31/07-06I 10245 Capitol Veiw Avenue
Kensington Historic District, 31/06

HISTORIC PRESERVATION COMMISSION STAFF REPORT

Address: 10245 Capitol View Ave, Silver Spring **Meting Date:** 05/10/06
Resource: Outstanding Resource **Report Date:** 05/03/06
 Capitol View Park Historic District
Review: HAWP **Public Notice:** 04/26/06
Case Number: 31/07-06I **ax Credit:** N/A
Applicant: Carl Mahany **Staff:** Michele Oaks
 (Tom Manion, Architect)

PROPOSAL: Construct two, new houses on the newly subdivided Lots 1 and 2.

HOUSE B - RIGHT ELEVATION

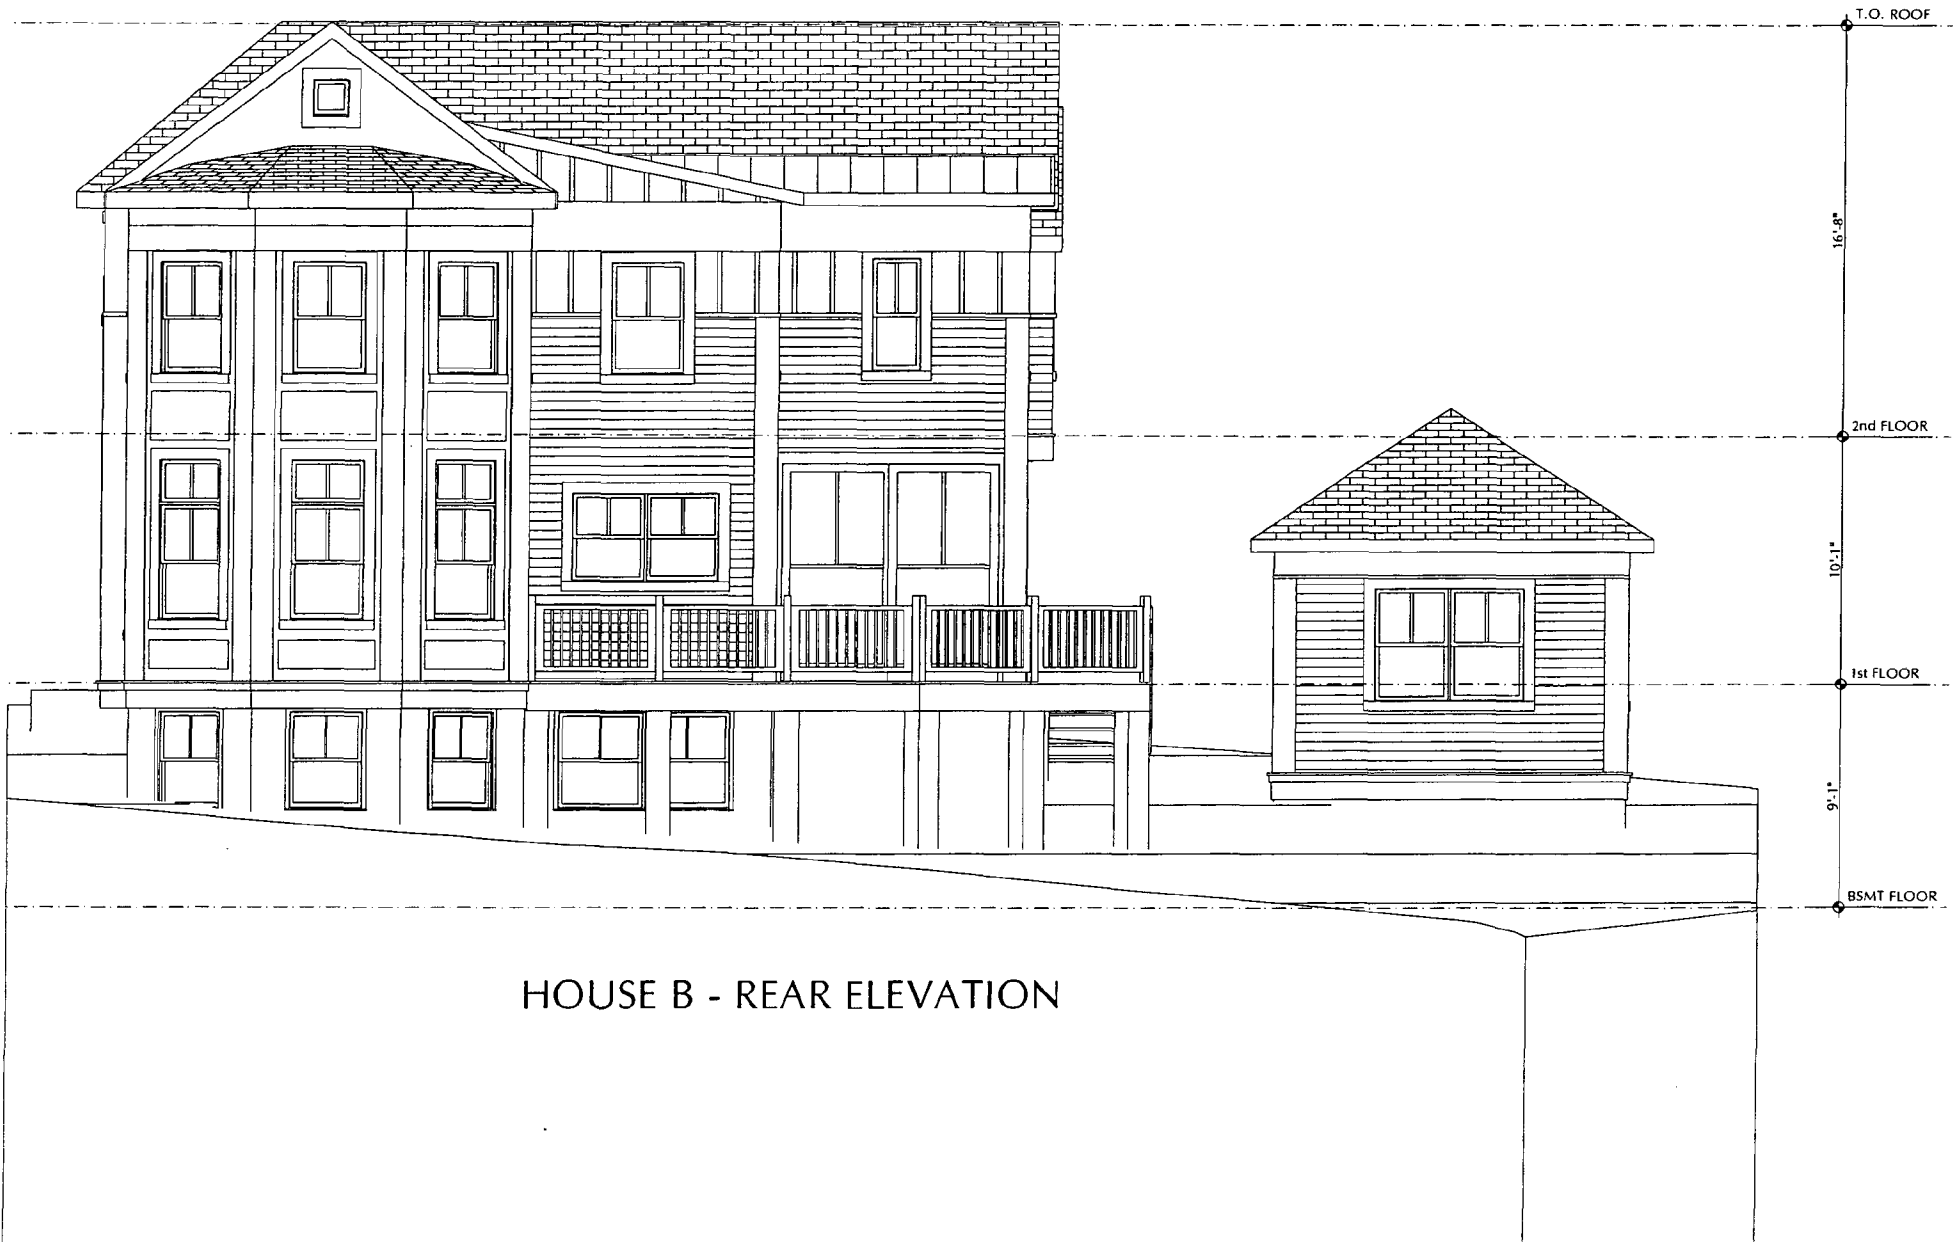
House A has had some modifications, which reflect the HPC's comments. The "tower" feature on the right elevation was eliminated and simplified to a hipped roof projection. The "supersized" siding reveals and the divided-light proportions in the larger windows have been changed in the projecting bay on the left elevation of the house. This was in response to the HPC's request to simplify. Additional changes to this house include the adjustment from two, double-hung windows on the second level of the front facade to an arched ribbon of windows and the porch roofing material changing to standing seam metal.

10 House A has had some modifications which we feel
11 reflect the HPC's comments. The tower feature on the right
12 elevation was eliminated, and it was simplified to a hip
13 roof projection.

HOUSE B - LEFT ELEVATION

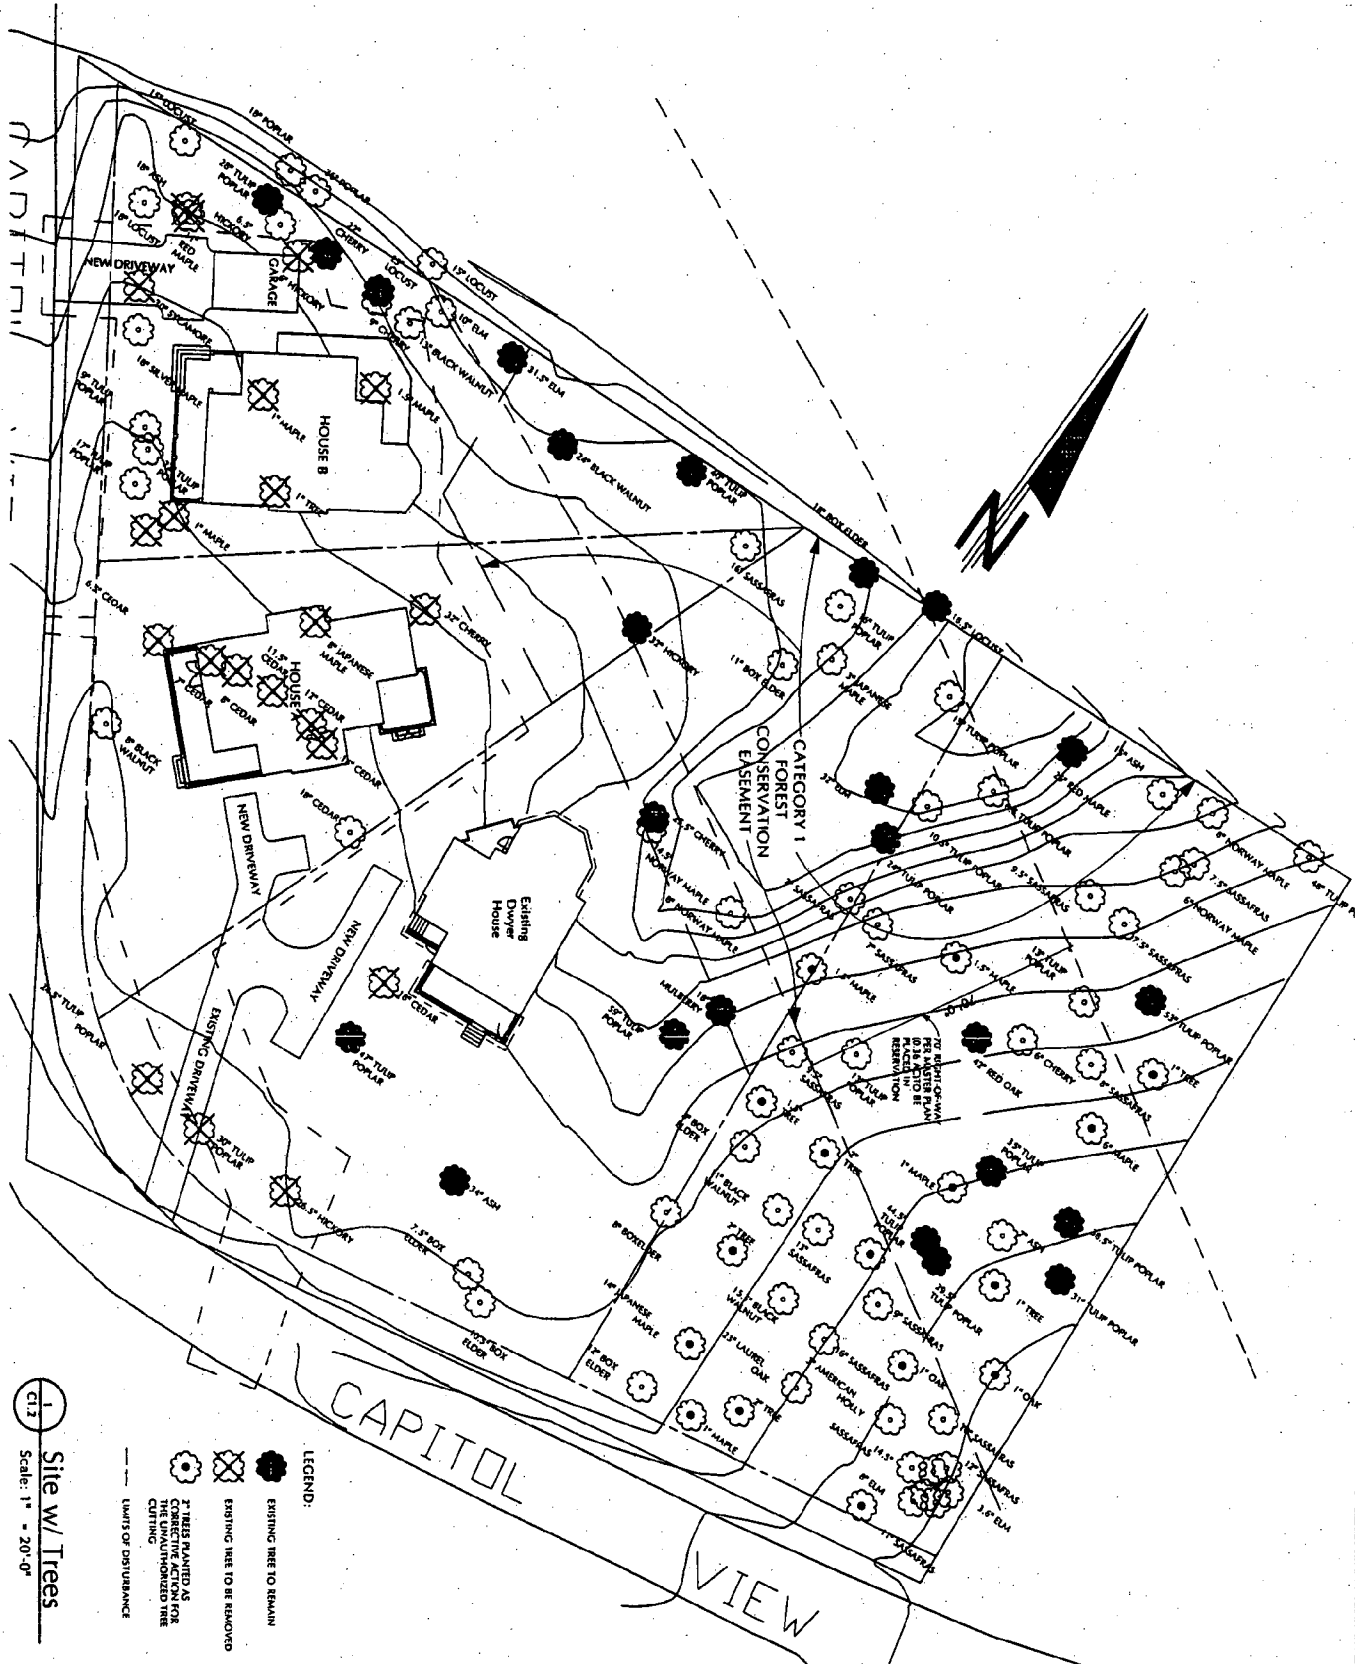
The major change to House B is in the exterior materials (see original design in preliminary consultation staff report beginning on circle). The applicant has completely changed their material selection for this house. The original house in the preliminary consultation contained horizontal clapboard siding with shingled gables. The current design utilizes board and batten in the gable ends and as a decorative band detail. Most of the building footprint is unaltered, however a second floor master bath was expanded. This expansion of the master bath requires a second roofline projection, which is visible on the left elevation.

The proposed material change on House B is very ornate in comparison with the previous design, as the Commission is striving for simplicity. Secondly, the roof projection on the left elevation for the master bath extension adds another element to this already complex facade. Therefore, we are recommending approval with the condition that the design is returned to the original design as submitted in the preliminary consultation.

5 MR. MANION: The house, the house never changed.
6 It actually shortened. So we don't have a problem with the
7 material changes, et cetera, but the house is actually a
8 different, slightly different shape. So I can't literally
9 match, but I can change the materials. I can take off the
10 verticals. I can do the shingles. The facade would be the
11 same. The rear northwest corner has two sheds instead of
12 one shed. It is, in fact, four feet shorter.

- Return elevations for House B to shingle/clapboard. Re-submit to staff for approval.

Subject: Dwyer House at 10245 Capitol View Ave, Kensington, MD

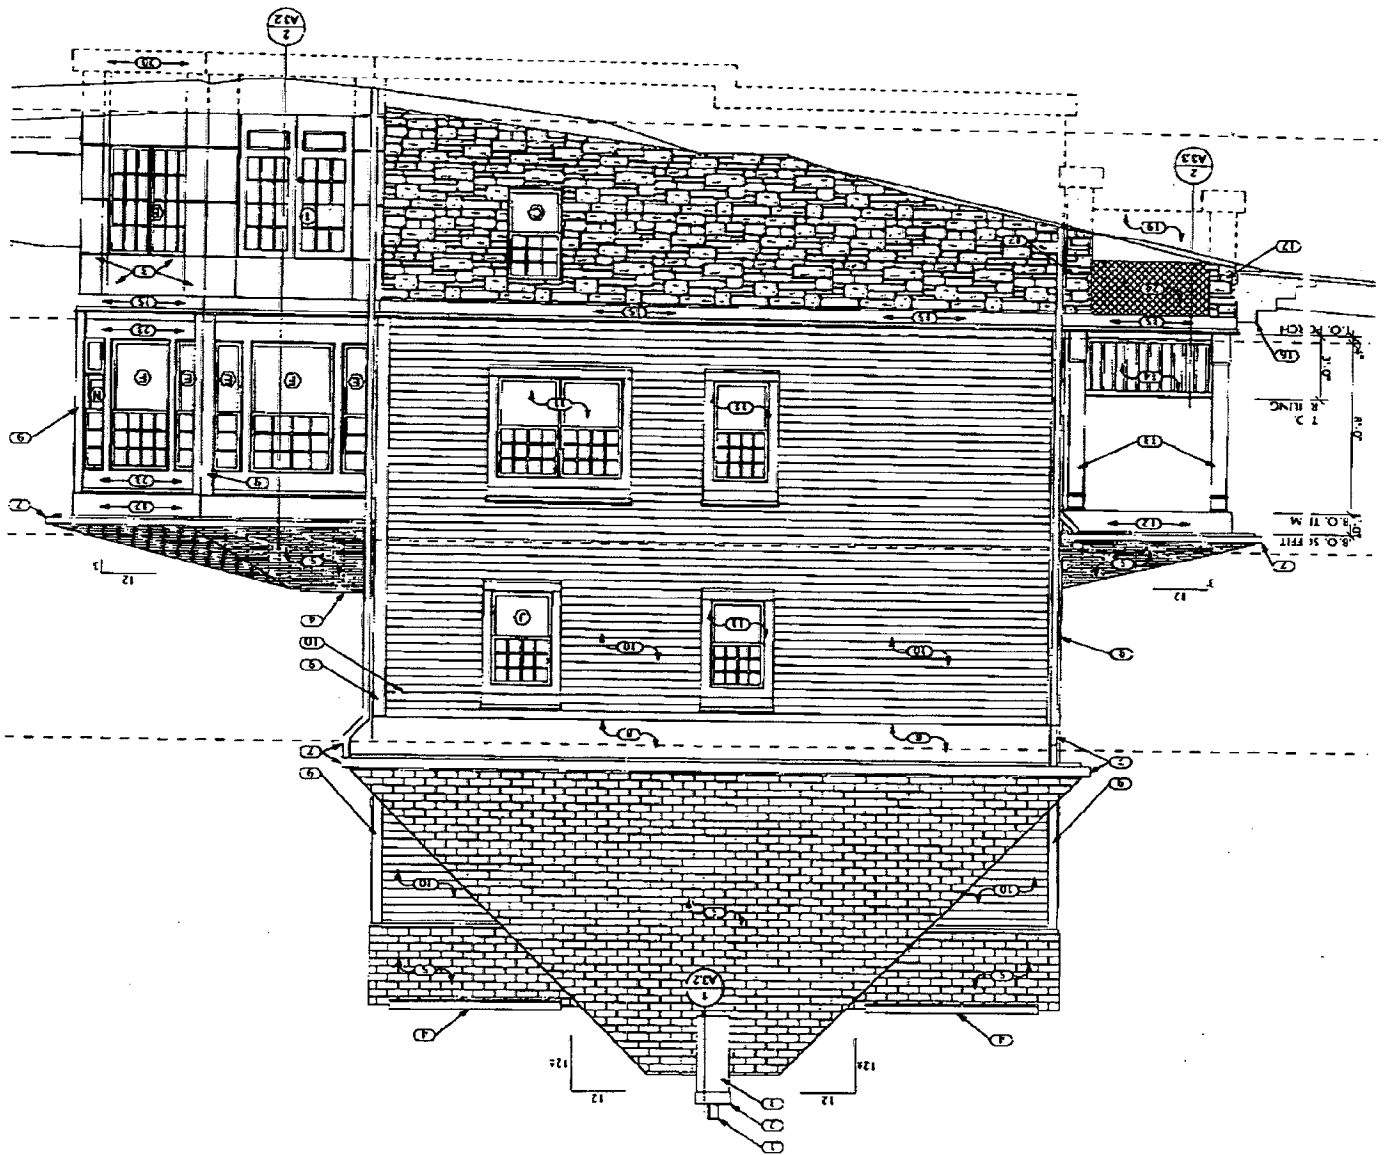
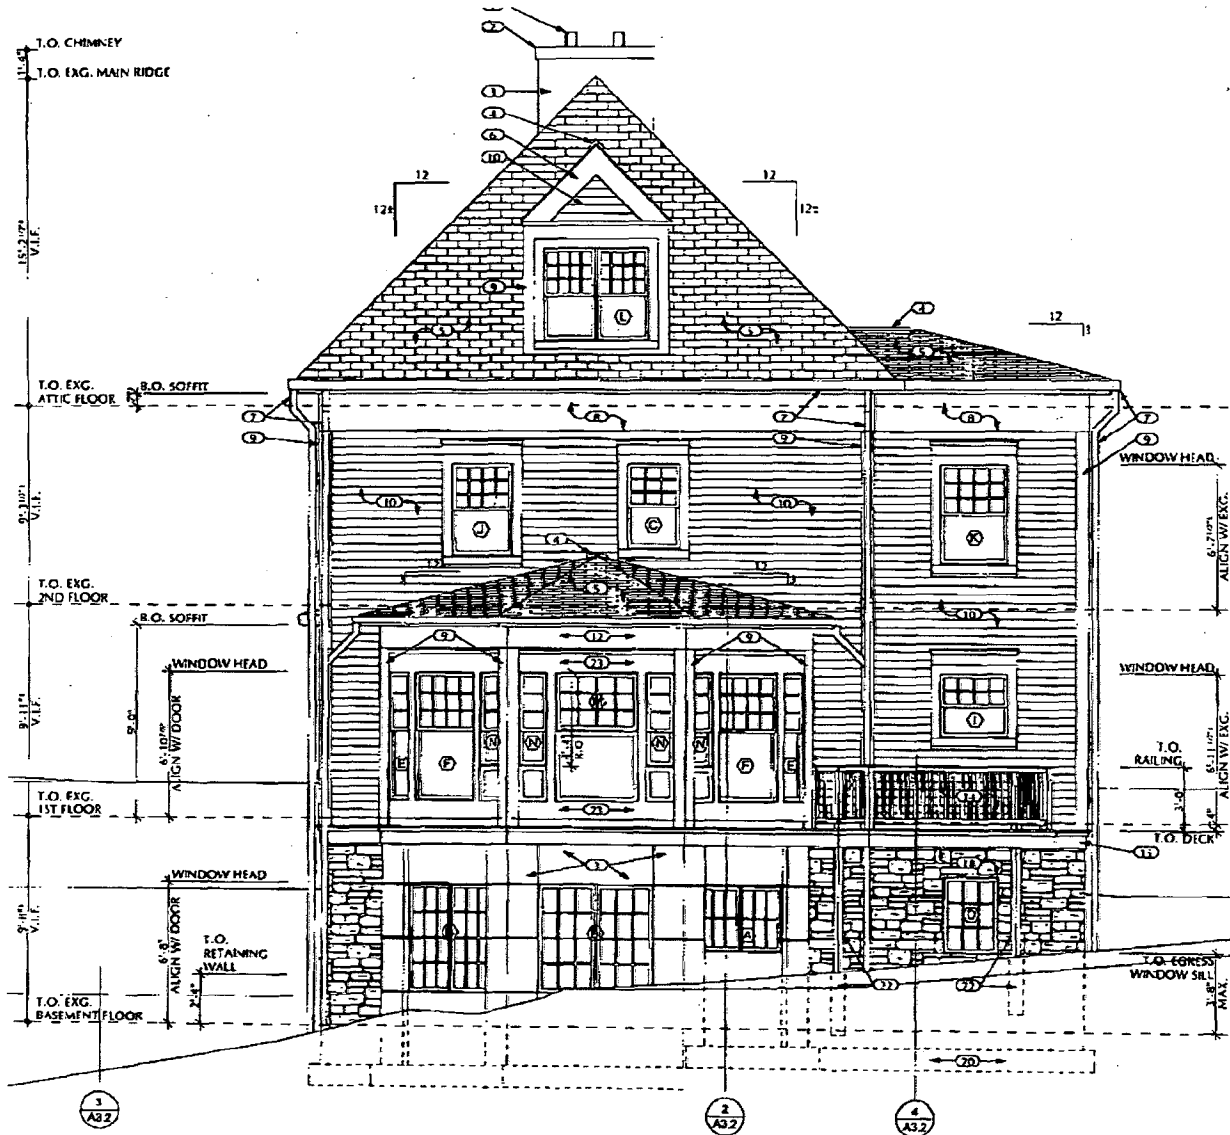
Message / Comments: Michele, these are some revised elevations for the Dwyer House. We had to slightly alter the facades. If you have any questions or need anything else please give me a call or give Carl Mahany a call. Thank you, Kathy

I am in receipt of your fax dated 12/23/05. The proposed modifications to the windows and doors on the rear addition of the Dwyer house is approved.
